SOLICITATION AMENDMENT MODIFICATION DE L'INVITATION

Title - Sujet CCGC Mechanical and Sprinklers	
Solicitation No. - N° de l'invitation EB144-190543/A	Amendment No. - N° modif. 008
Client Reference No. - N° de référence du client EB144-19-0543	Date 2018-08-14
GETS Reference No. - N° de référence de SEAG PW-\$PWA-121-5750	
File No. - N° de dossier PWA-8-80020 (121)	CCC No./N° CCC - FMS No./N° VME
Solicitation Closes - L'invitation prend fin at - à 02:00 PM on - le 2018-08-21	Time Zone Fuseau horaire Atlantic Daylight Saving Time ADT
F.O.B. - F.A.B. Plant-Usine: <input type="checkbox"/> Destination: <input checked="" type="checkbox"/> Other-Autre: <input type="checkbox"/>	
Address Enquiries to: - Adresser toutes questions à: Russell (PWA), Alex	Buyer Id - Id de l'acheteur pwa121
Telephone No. - N° de téléphone (902) 401-8180 ()	FAX No. - N° de FAX (902) 496-5016
Destination - of Goods, Services, and Construction: Destination - des biens, services et construction:

ADDENDUM NO. 2

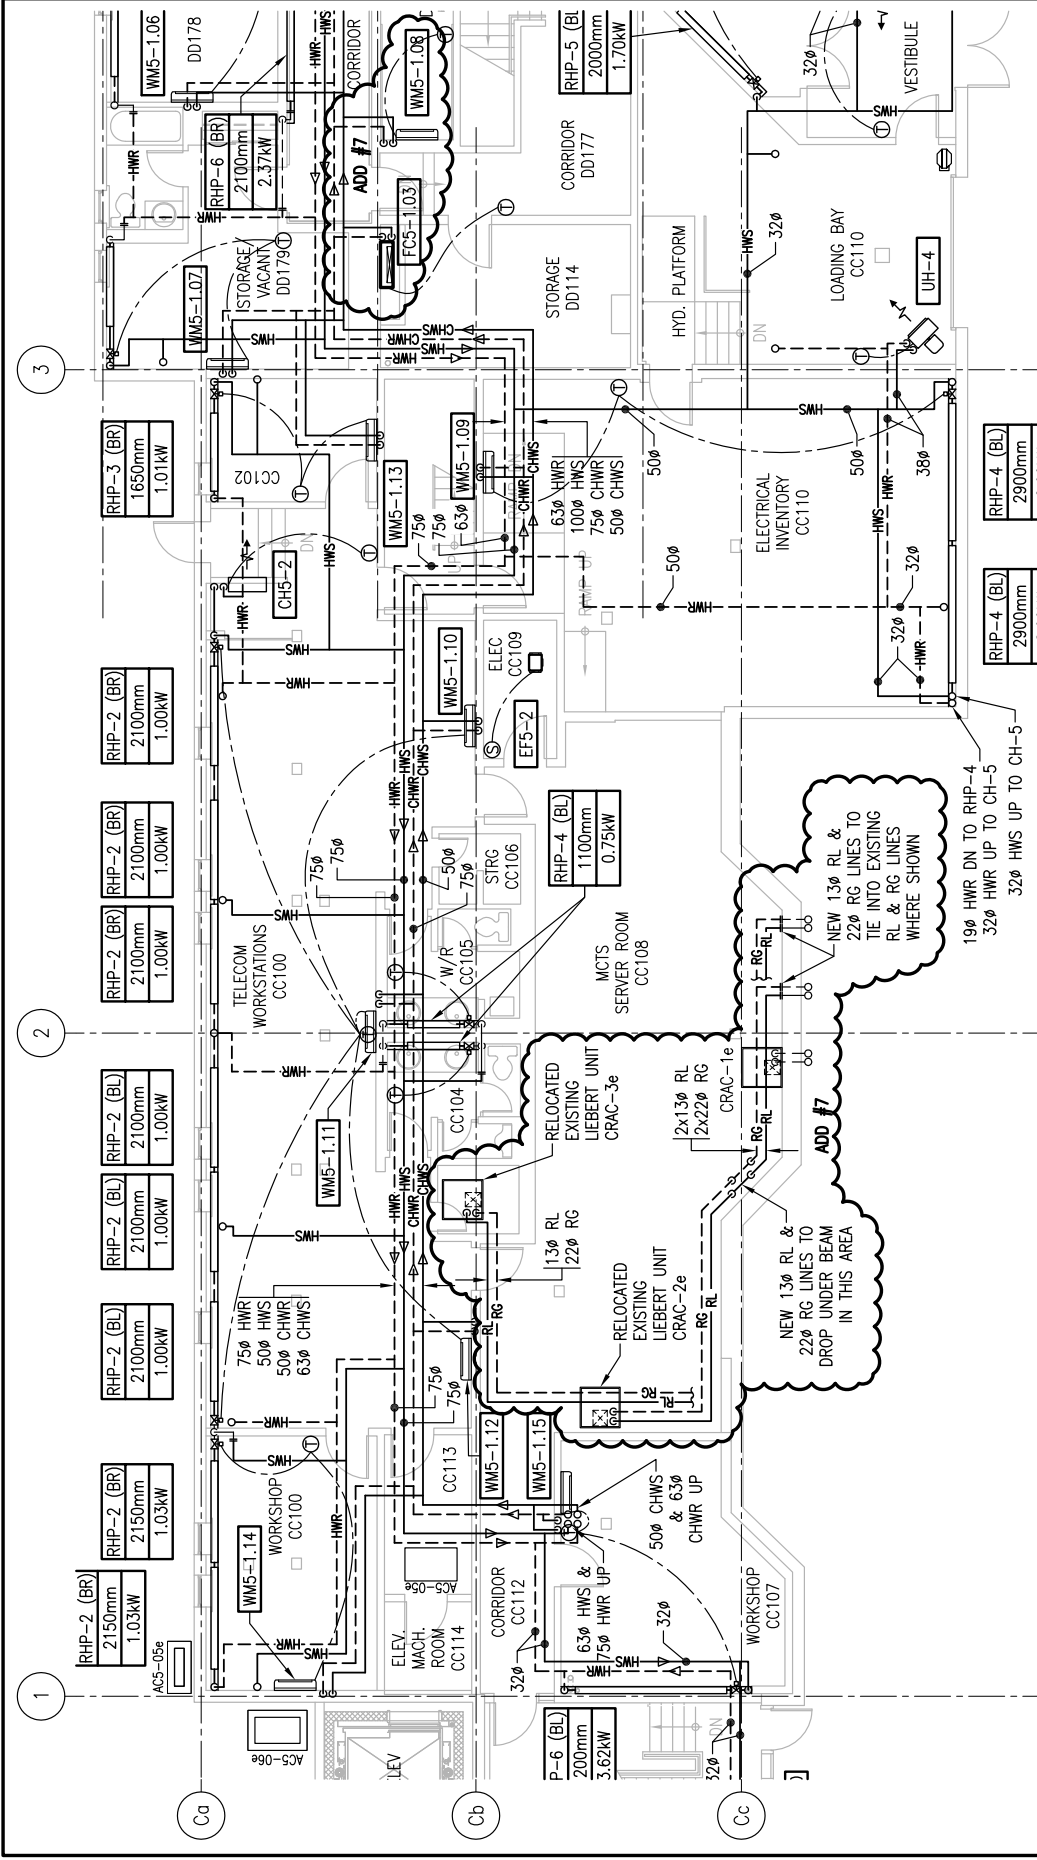
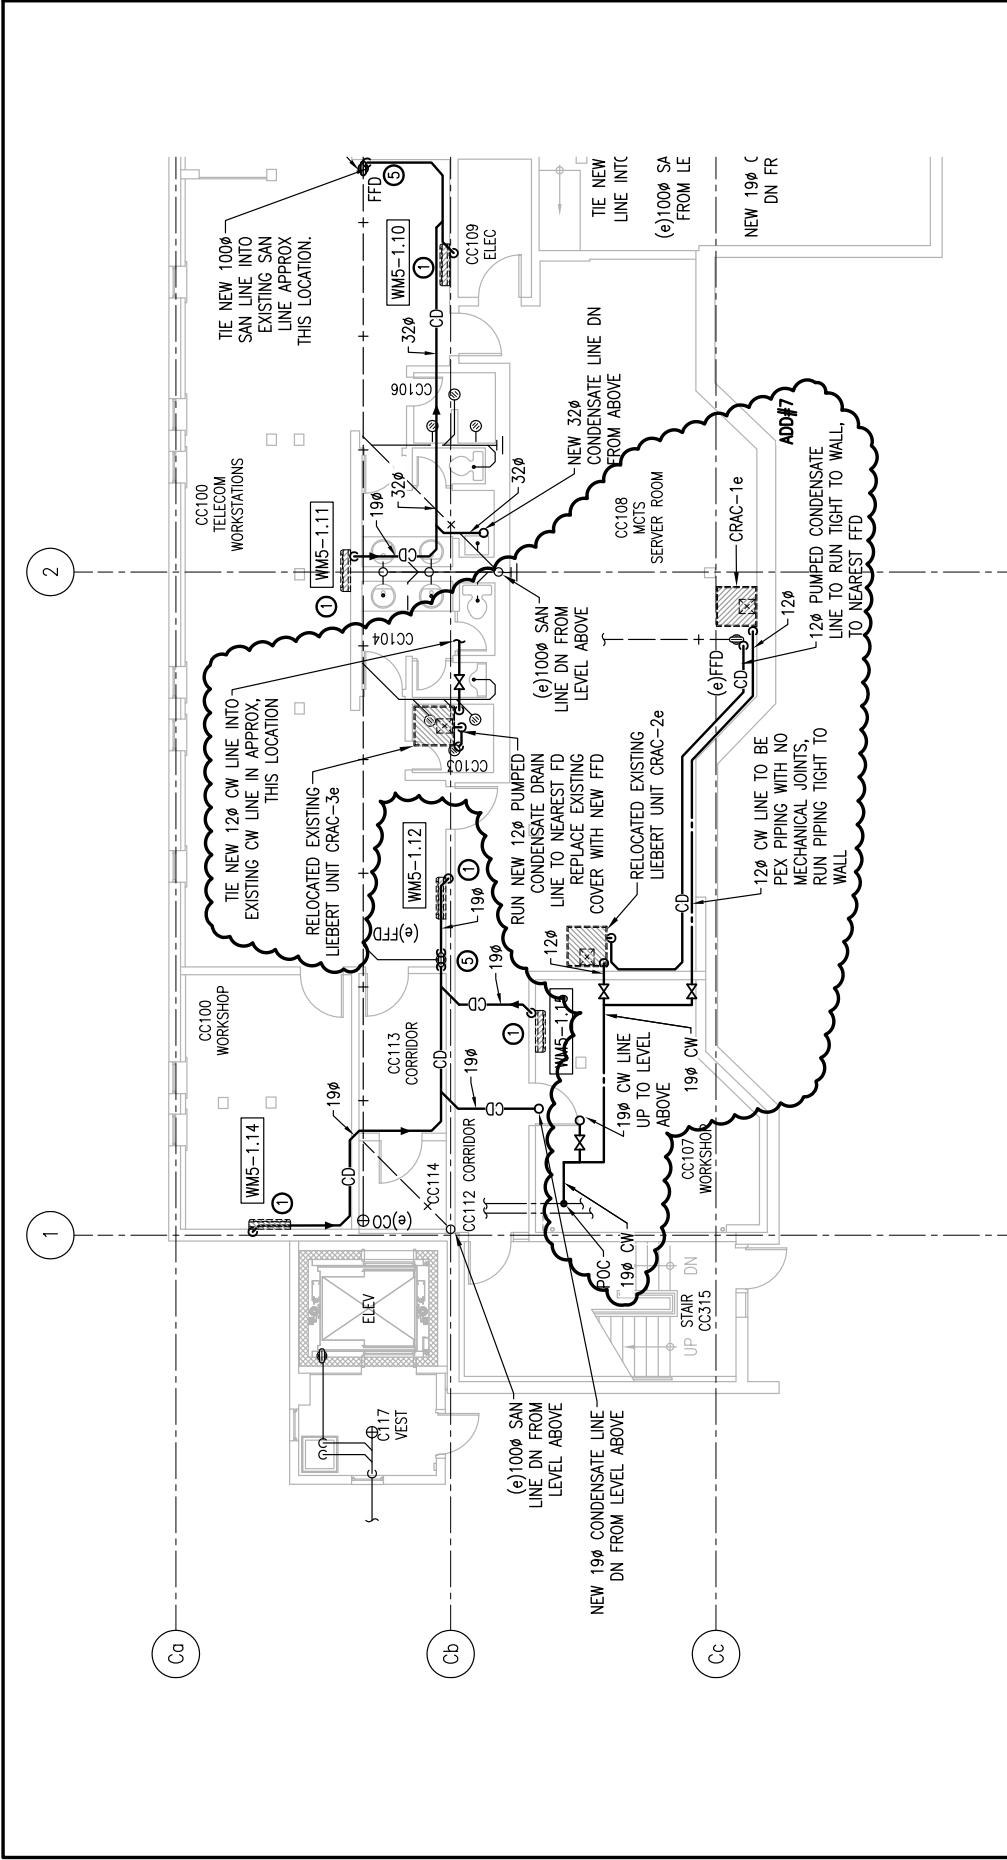
Item 3.47 DRAWING 05-MH-101 HVAC PIPING – TELC/MCTS – LEVEL 100 – 200 NEW WORK

- .1 Revise the drawing as per the attached Sketch 05-MH-SK001(This Addendum).
- .2 Level 100 – Remove RL and RG piping shown between WM5-1.08 (MacKenzie) and existing Condensing Unit AC5-06e. Provide new 19mm CHWS & CHWR branch lines to serve WM5-1.08 from 50mm CHWS & 75mm CHWR lines running above corridor ceiling.
- .3 Level 100 – Provide new CHWS & CHWR branch lines to serve ducted fan coils FC4-1.03 from CHWS & CHWR lines running above corridor ceiling.
- .4 Level 200 – Provide new CHWS & CHWR branch lines to serve ducted fan coils FC4-2.01, FC4-2.02, FC4-2.03, & FC4-2.04 from CHWS & CHWR lines running through level 200 corridor ceiling.

WALL MOUNTED FAN COIL DETAILS - 7

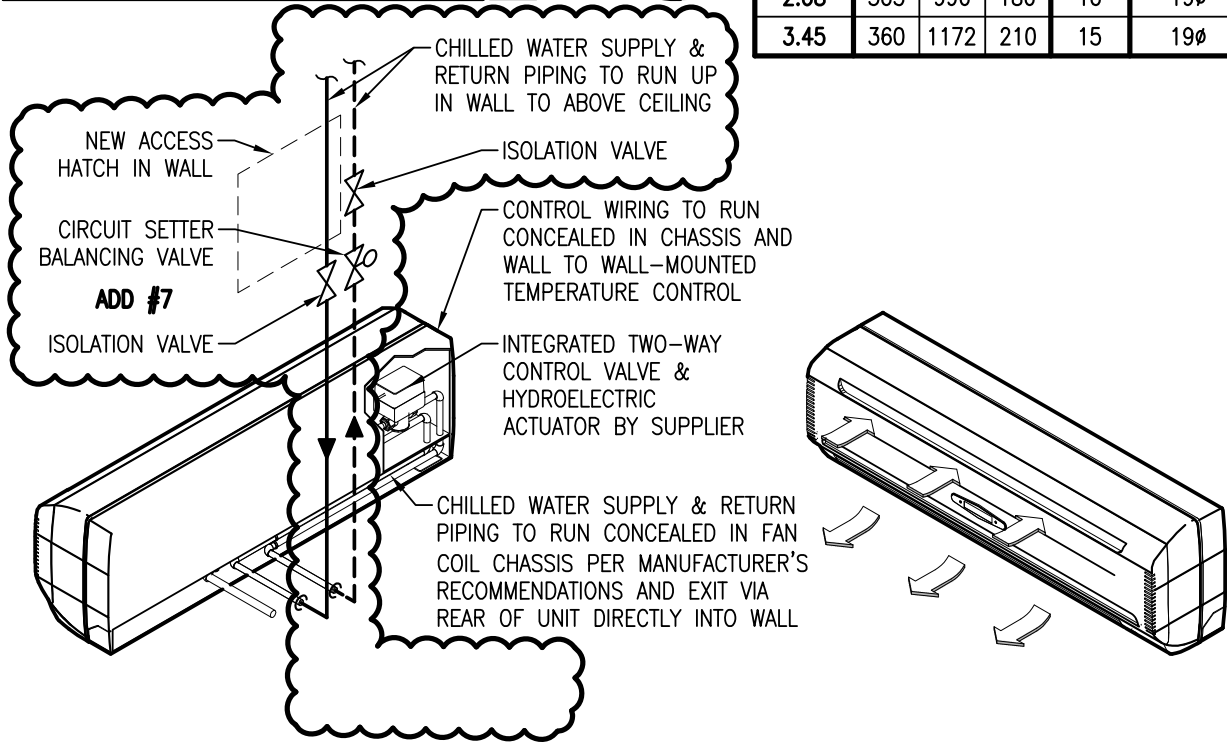
Item 3.57 DRAWING 06-MH-502 ALERT HVAC PIPING DETAILS

- .1 Revise Detail 7 of this drawing per Sketch 06-MH-SK004 HVAC Piping Wall Mounted Fan Coil Detail Revisions dated 2018-08-10 (This Addendum).

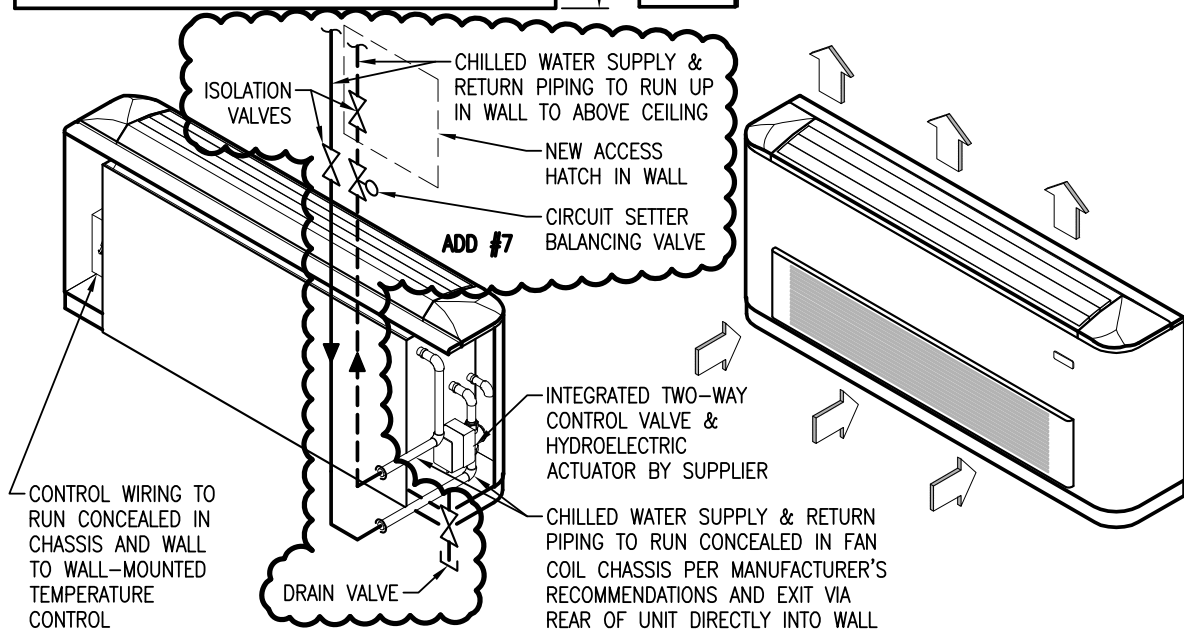
- .2 Revise Detail 8 of this drawing per Sketch 06-MH-SK005 HVAC Piping Wall Mounted Fan Coil Detail Revisions dated 2018-08-10 (This Addendum).
- .3 Revise Detail 9 of this drawing per Sketch 06-MH-SK006 HVAC Piping Wall Mounted Fan Coil Detail Revisions dated 2018-08-10 (This Addendum).
